Town of Hilton Head Island Regular Design Review Board Meeting

Tuesday, February 14, 2012

AGENDA

Town of Hilton Head Island
Design Review Board
Minutes of the Tuesday, January 24, 2012 Meeting **DRAFT**
1:15pm – Benjamin M. Racusin Council Chambers

SITE PLAN

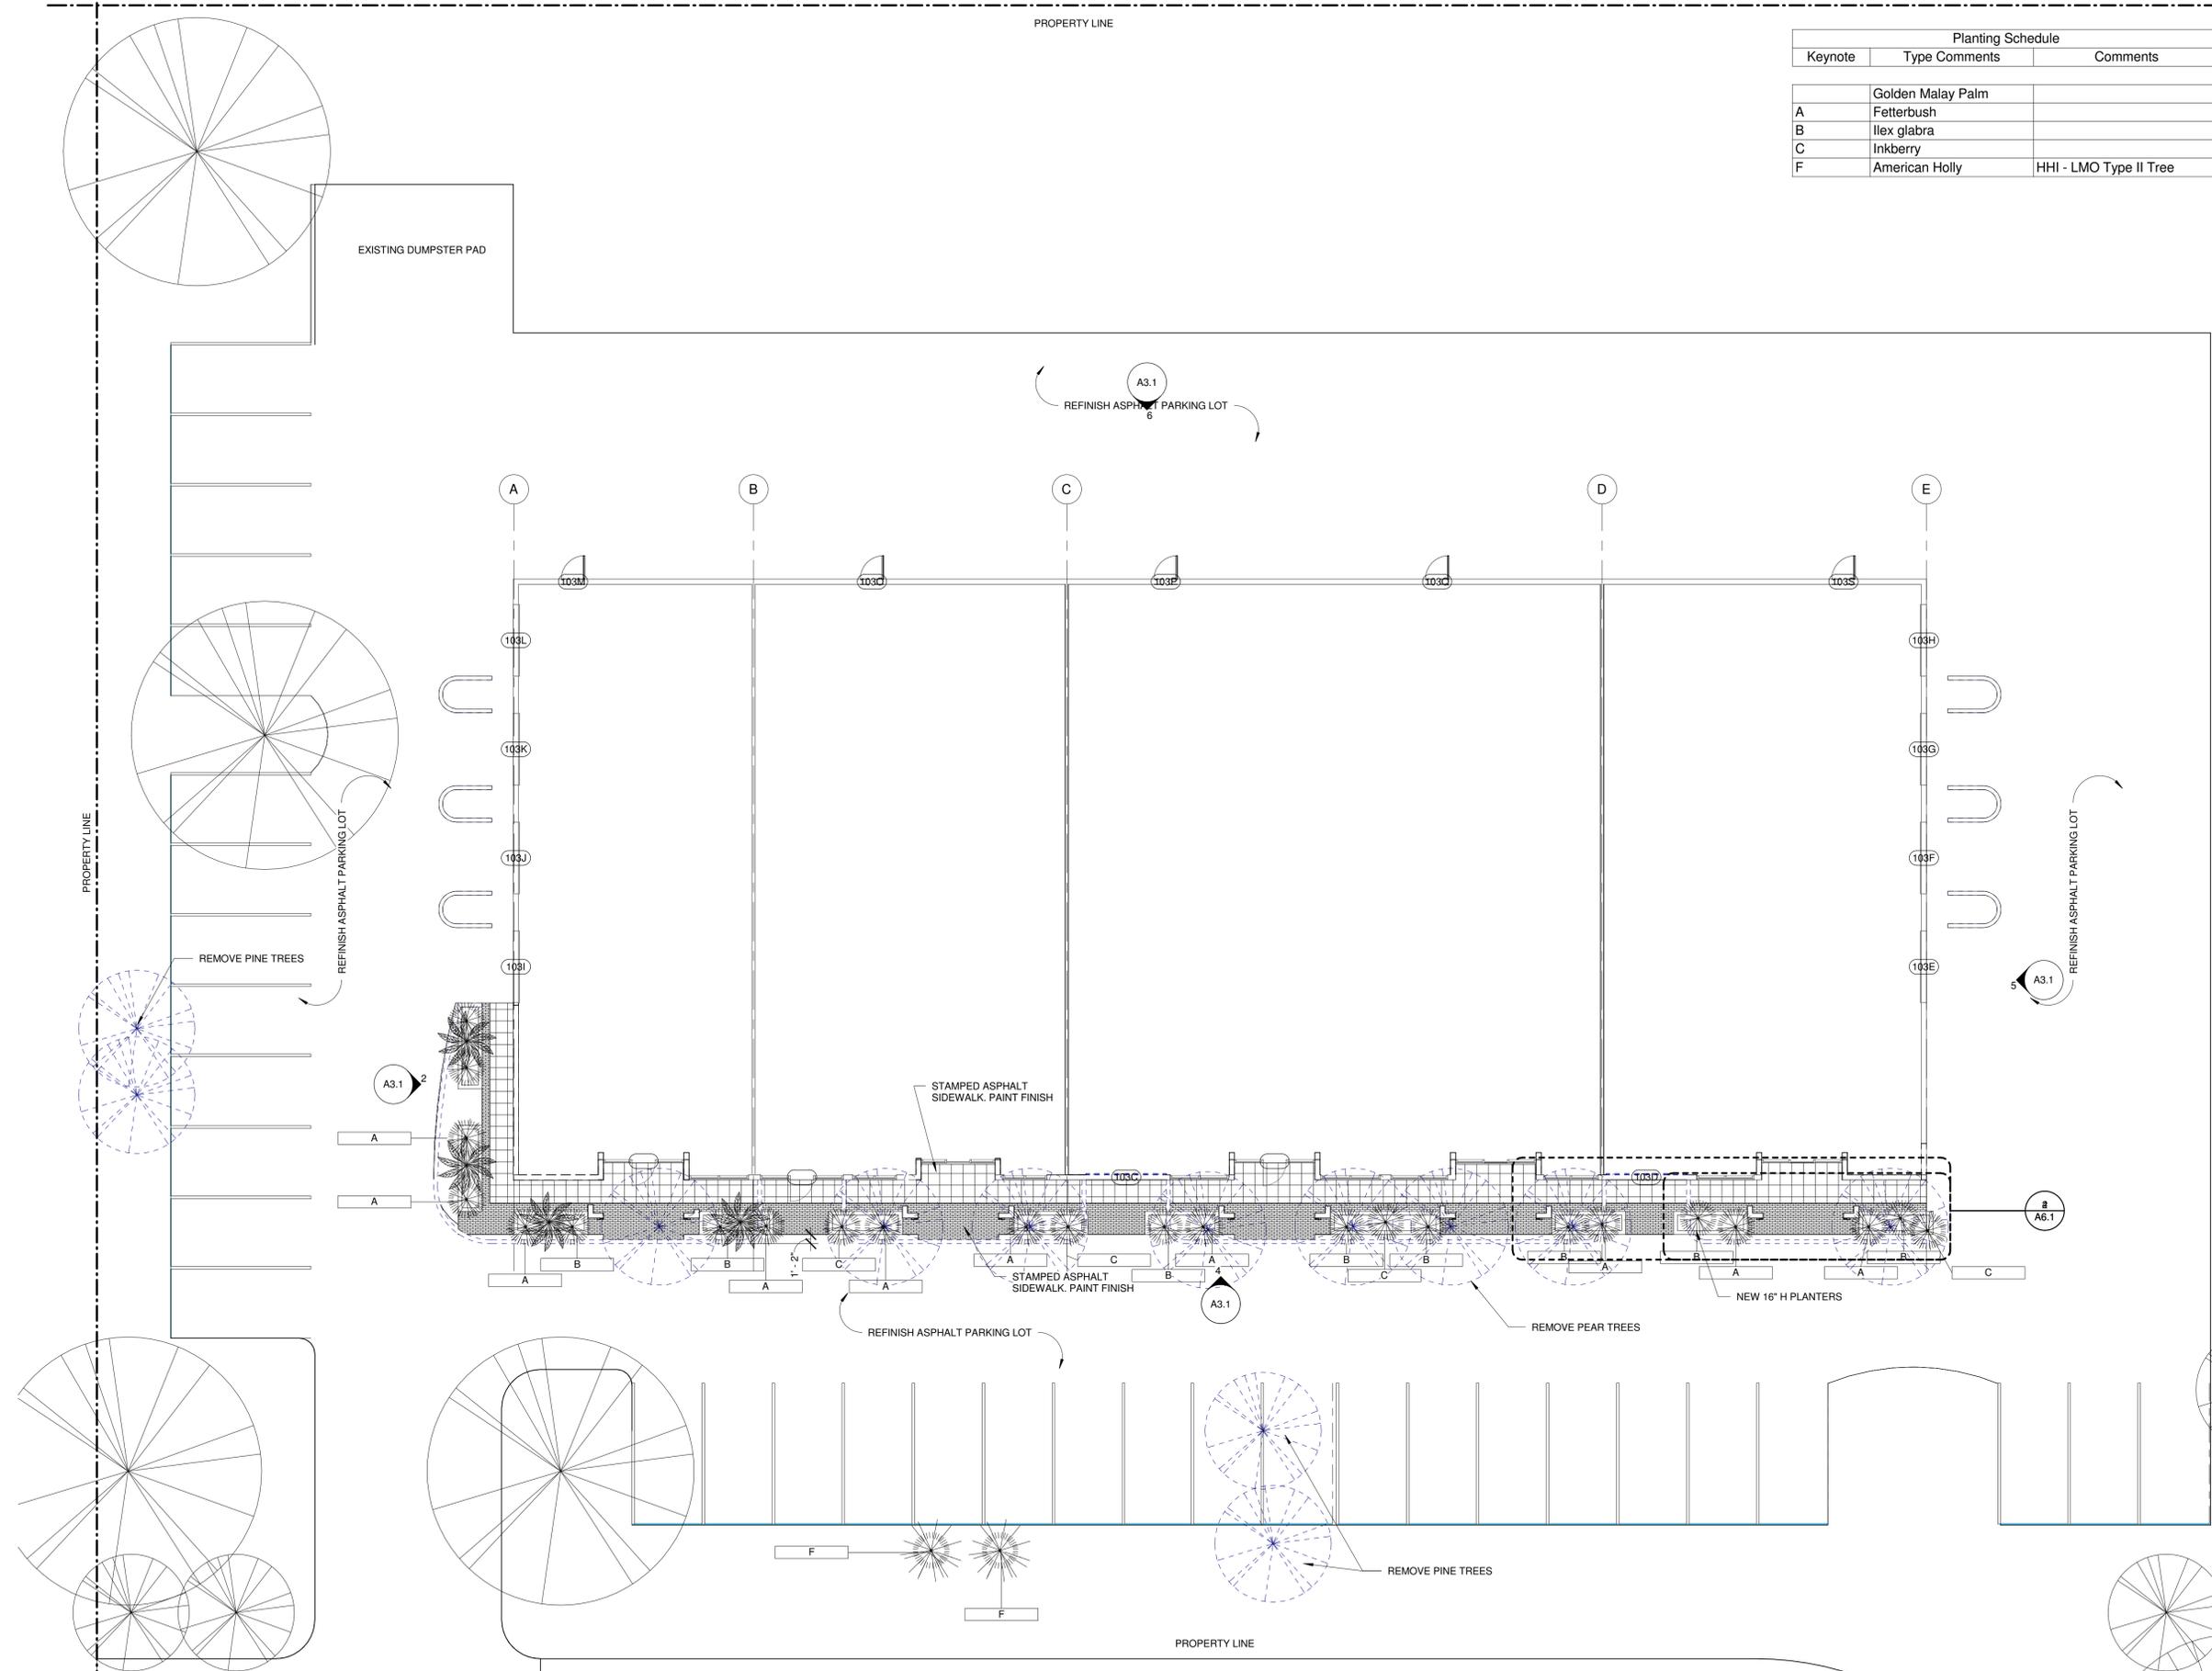
Tree mitigation in the form of American Hollies will do little to address the direction of the Board relative to the trees in the parking median, and should be substituted with what will become an overstory tree. Natural Resources has given the option of replacing with four (4) pines, or two (2) Cat. 1 or 2 trees (overstory species). Staff would recommend mitigating with Live Oaks at opposite ends of the island, to the extent possible, to provide a future canopy and ultimately frame views into the building without obstructing visibility.

EXISTING ELEVATIONS

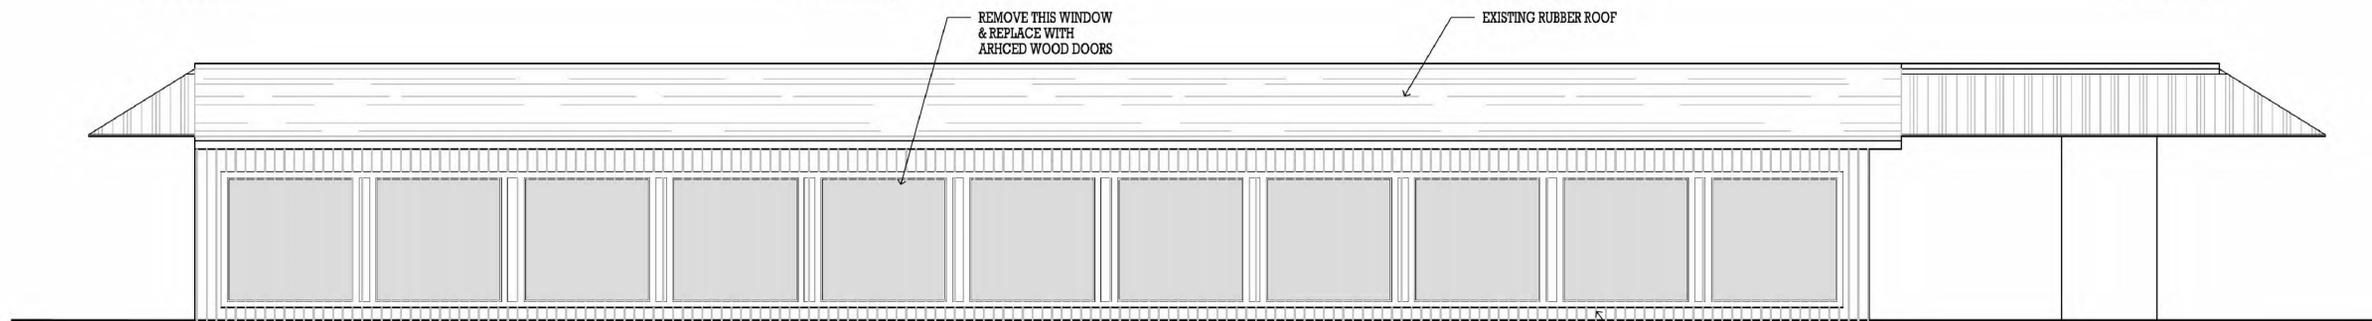
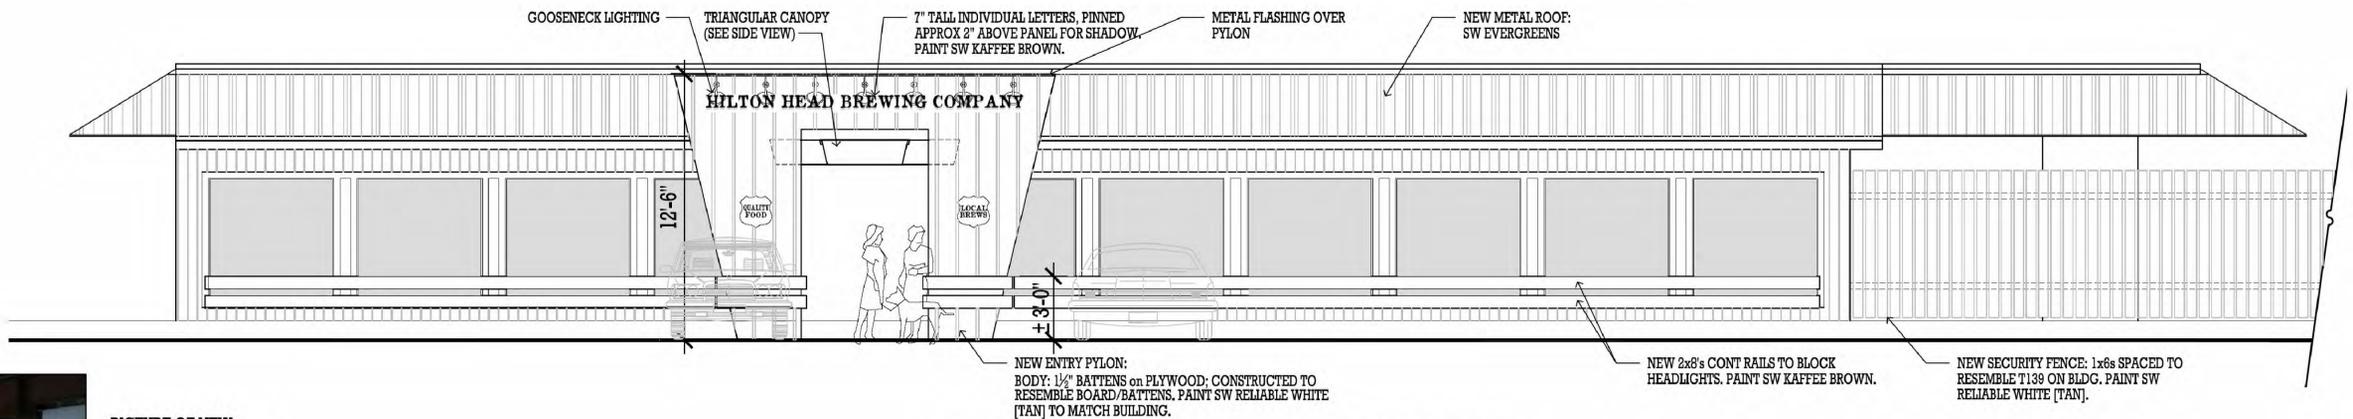
Extending the railing detail across the windows helps shield diners from headlights, and integrates the patio and restaurant. While the reclaimed door is of a high quality, it seems provincial relative to the "roadside" architectural style of the new storefront. Applicant should also provide some detail showing how the existing pergola is finished once the existing deck is removed. Perhaps the ogee end cuts on the trellis pieces should be revisited to reflect the style of the new theme, as well

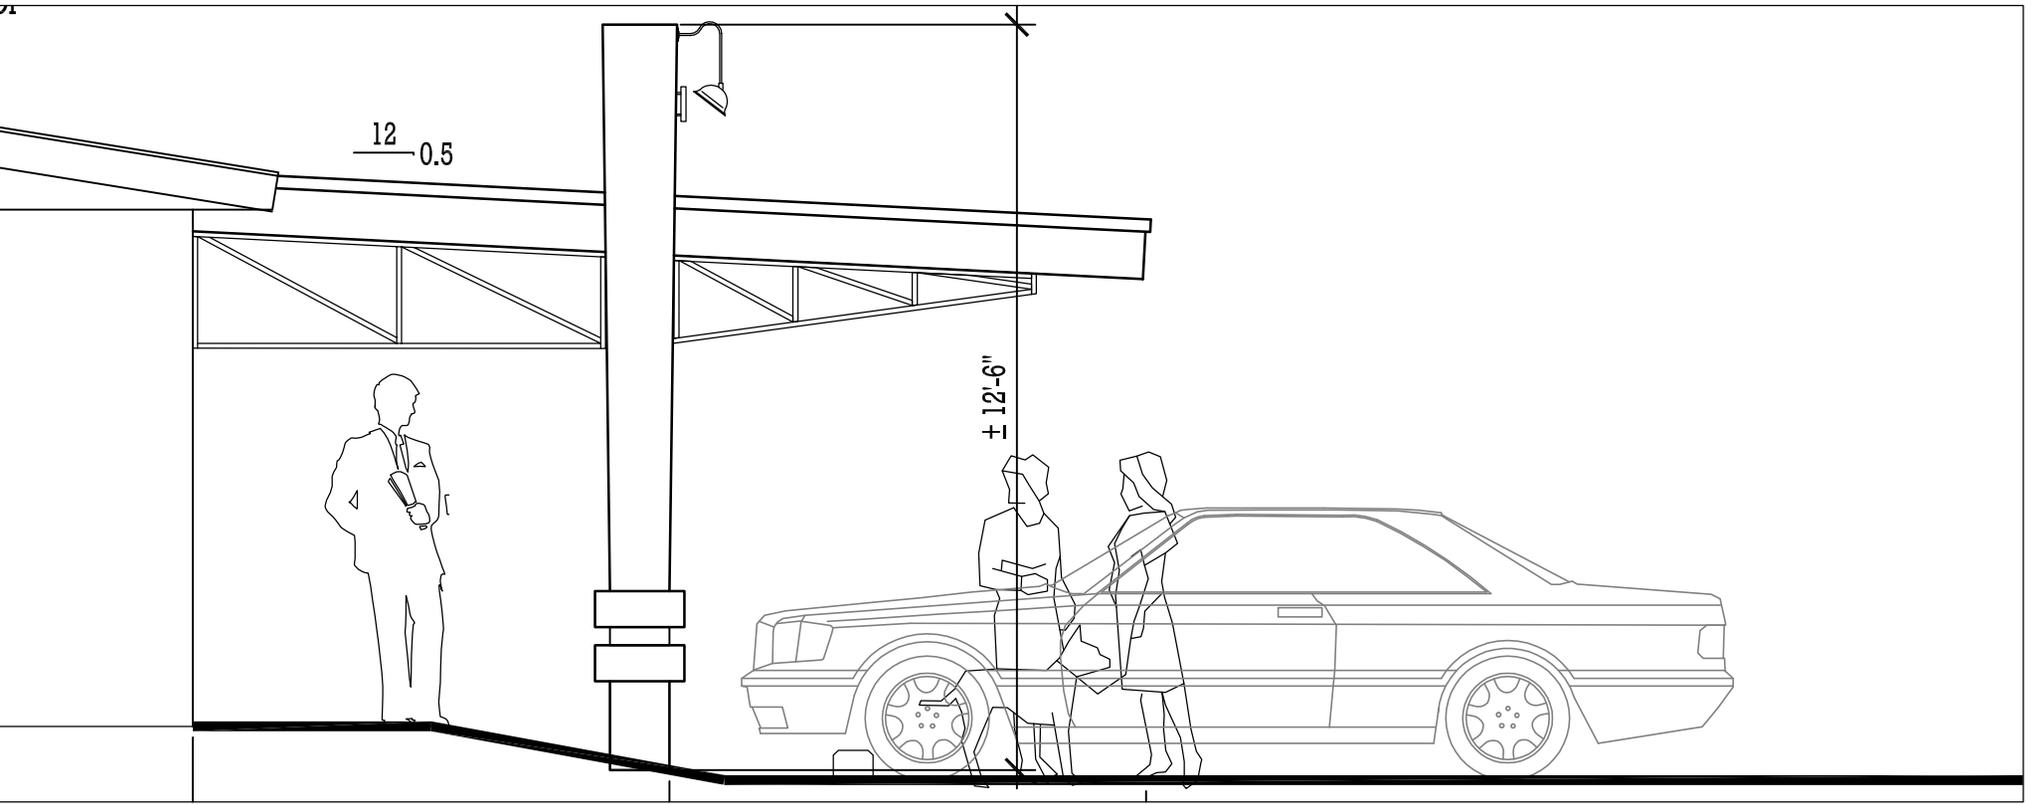
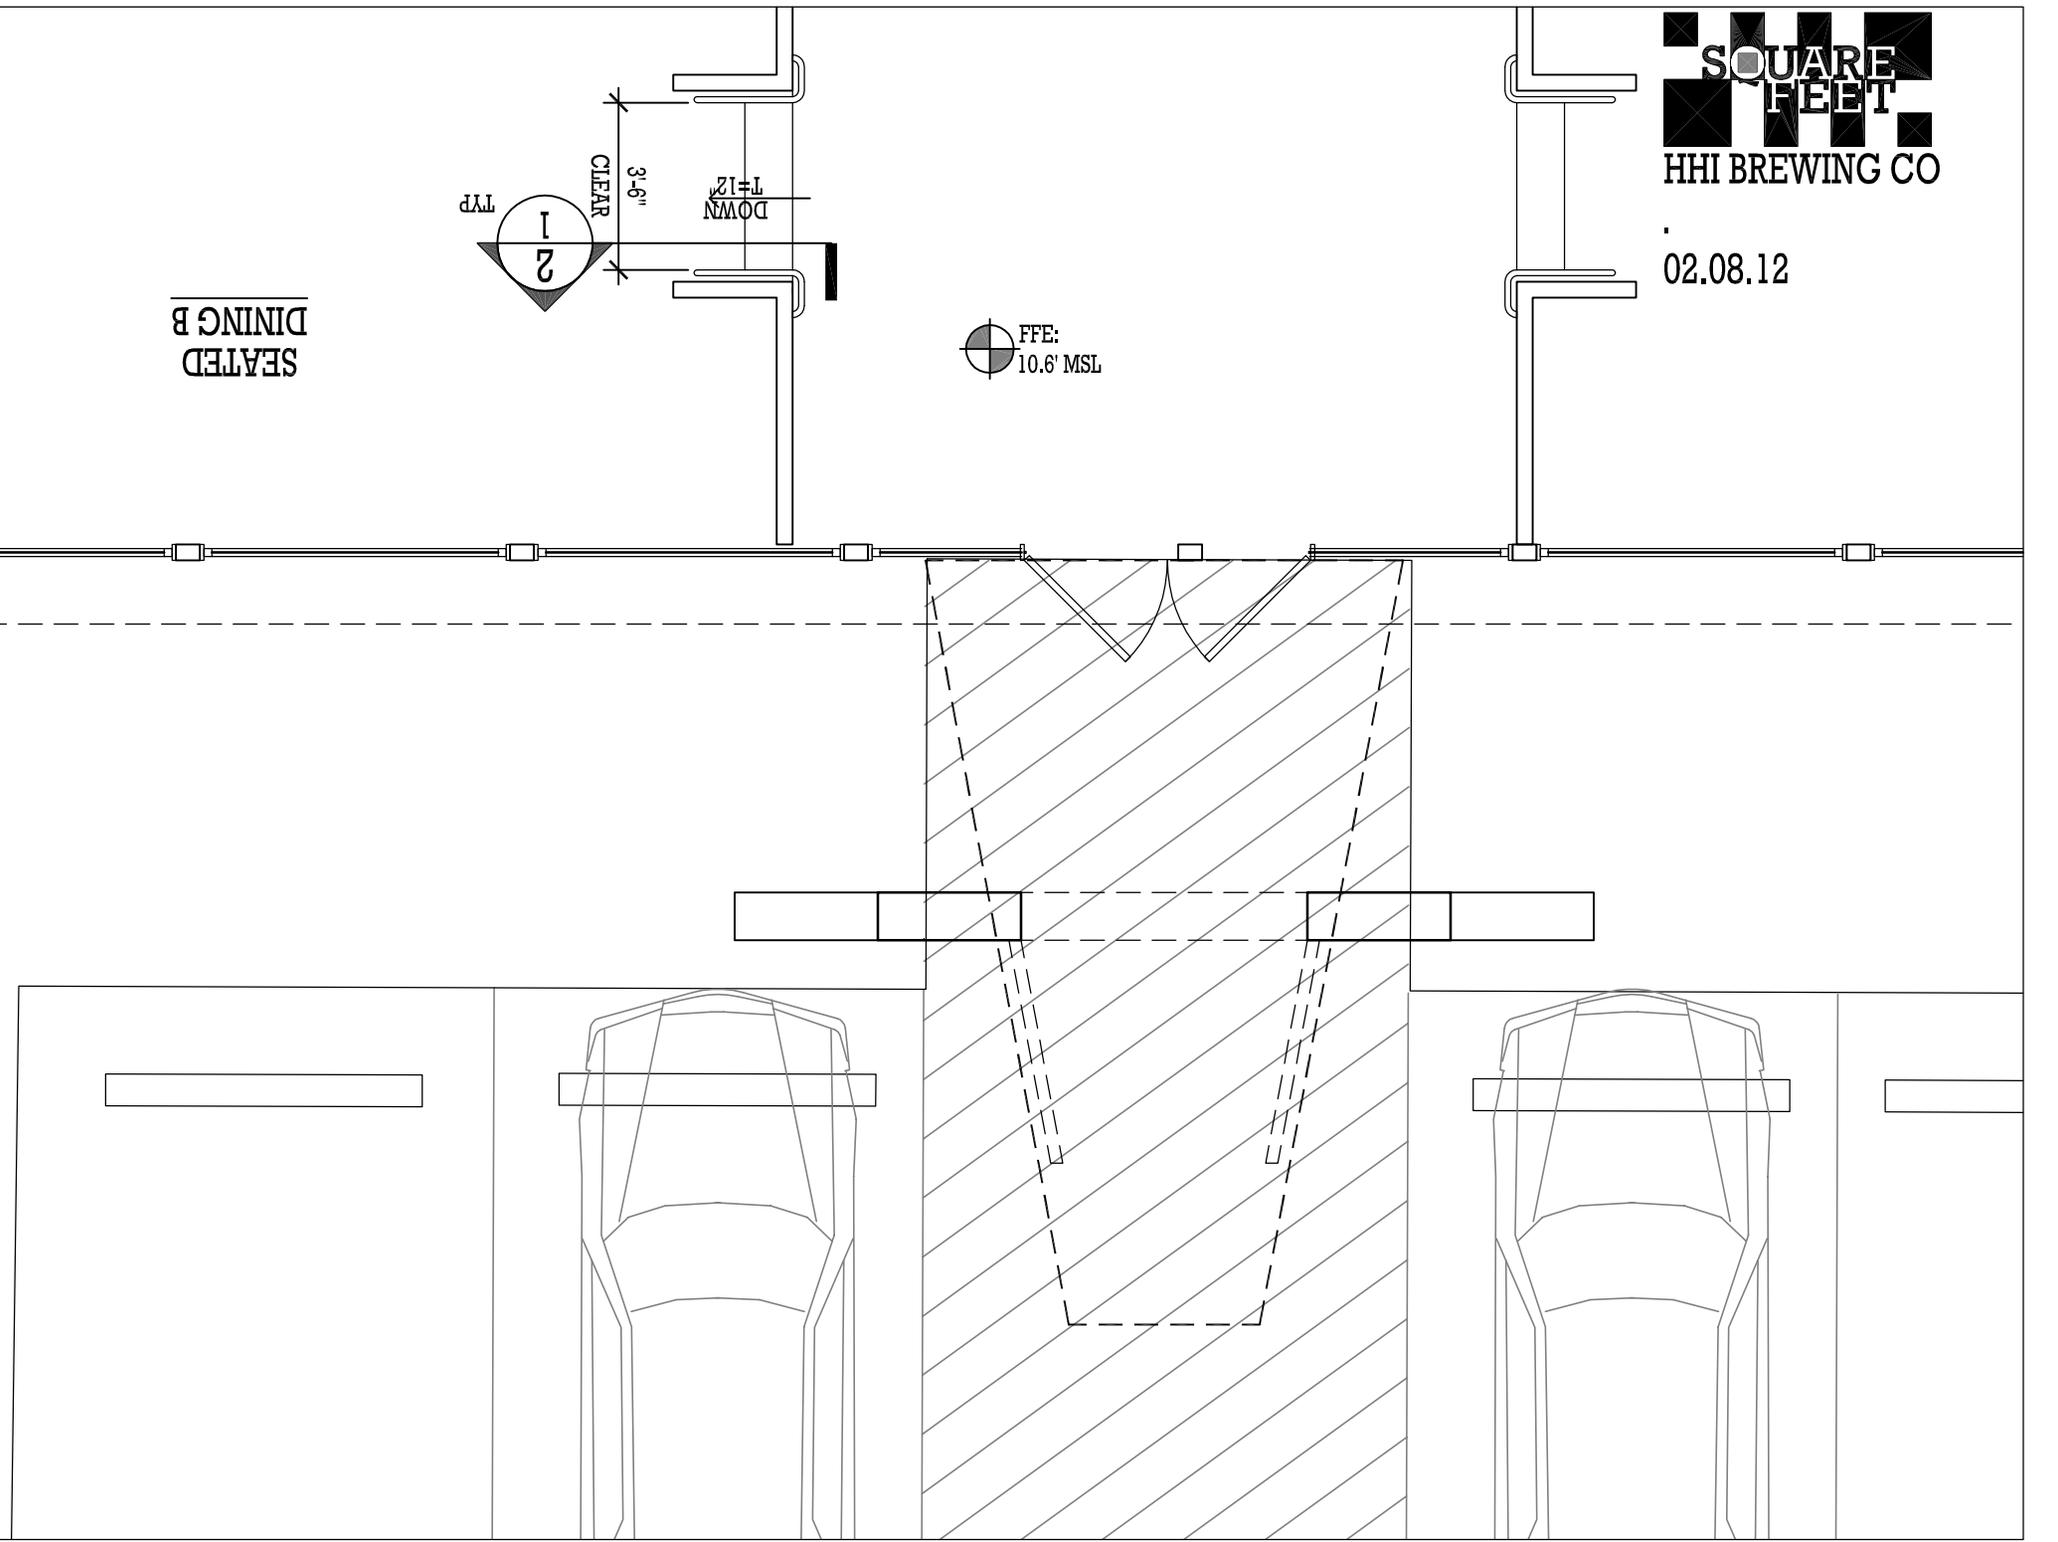
As part of the parking expansion, applicant is required to provide a landscape plan which illustrates how the buffers are maintained and reinforced. Some landscaping at the storefront should also be included. Applicant has been notified and is bringing in a plan for review at the meeting.
